An Addendum to a Report on Landscape and Ecological Constraints – Land at Fitzroy Park

Prepared on Behalf of Mr. John Kennedy

JFA Ref: LON 2048

March 2020

Defra Magic map with 100m buffer on the closest ponds (in red). The blue area approximates land to be loss of damaged within 100m of the two nearest ponds = 500m² or 0.05ha will be lost or damaged (in blue).

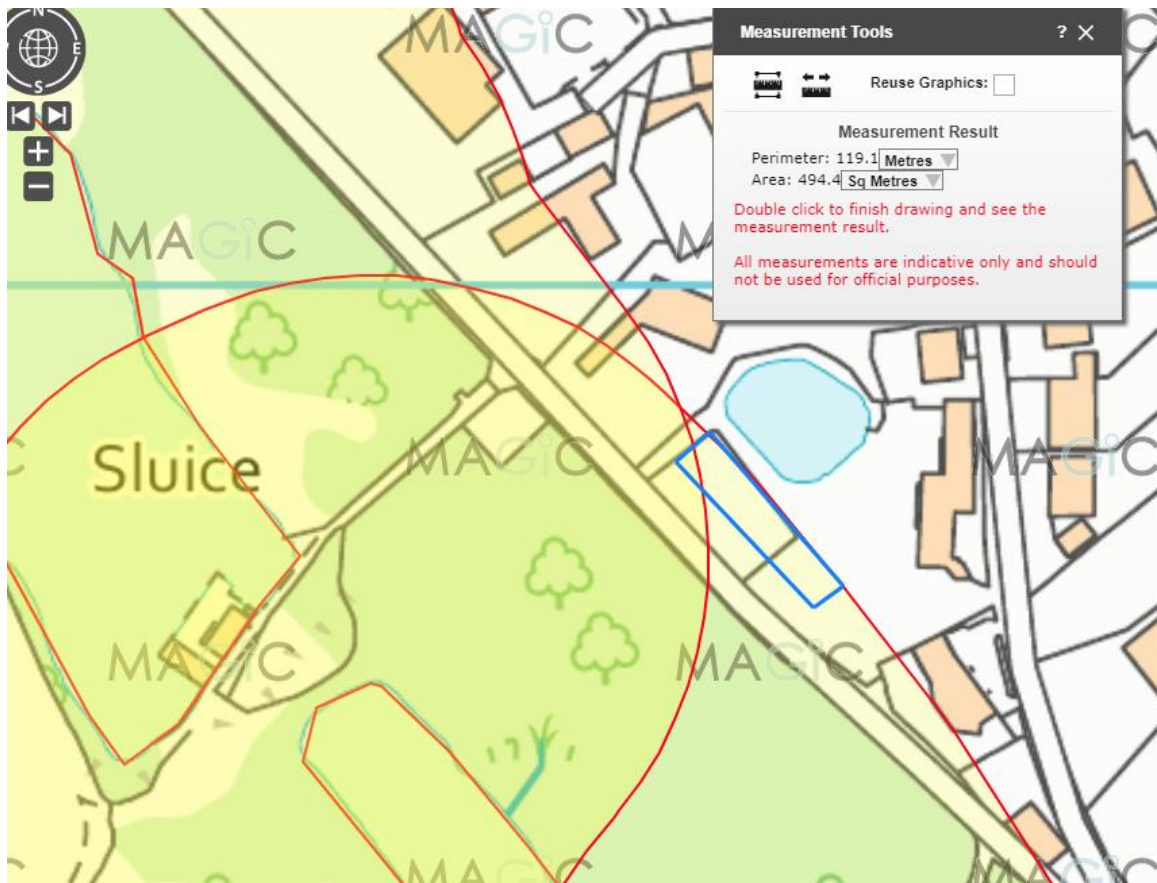
- 2.12 LUC has also justified their approach using the Natural England risk assessment tool. However, the figure they have inputted for ponds within 100m is too low and instead of 0.001-0.01 ha lost or damaged they should have entered the next category 0.01 -0.1 ha lost or damaged (see map below). This would have produced an amber result, offence likely. This would have required further assessment of the ponds offsite to ensure a breeding pond was not within 250m.

Component	Likely effect (select one for each component; select the most harmful option if more than one is likely; lists are in order of harm, top to bottom)	Notional offence probability
Great crested newt breeding pond(s)	No effect	0
Land within 100m of any breeding pond(s)	0.01 - 0.1 ha lost or damaged	0.3
Land 100-250m from any breeding pond(s)	No effect	0
Land >250m from any breeding pond(s)	No effect	0
Individual great crested newts	No effect	0
	Maximum:	0.3
Rapid risk assessment result:	AMBER: OFFENCE LIKELY

- 2.13 As a minimum, scores from a habitat suitability assessment are required to justify that the five ponds within 250m of the site are unsuitable to support GCN rather than anecdotal evidence.
- 2.14 Just as in the conclusion on bats above- the applicant has failed to provide the LPA with sufficient information (in the form of surveys and the correct use of risk assessment tools) to ensure that any harm to great crested newts, a specially protected species, is sufficiently mitigated.
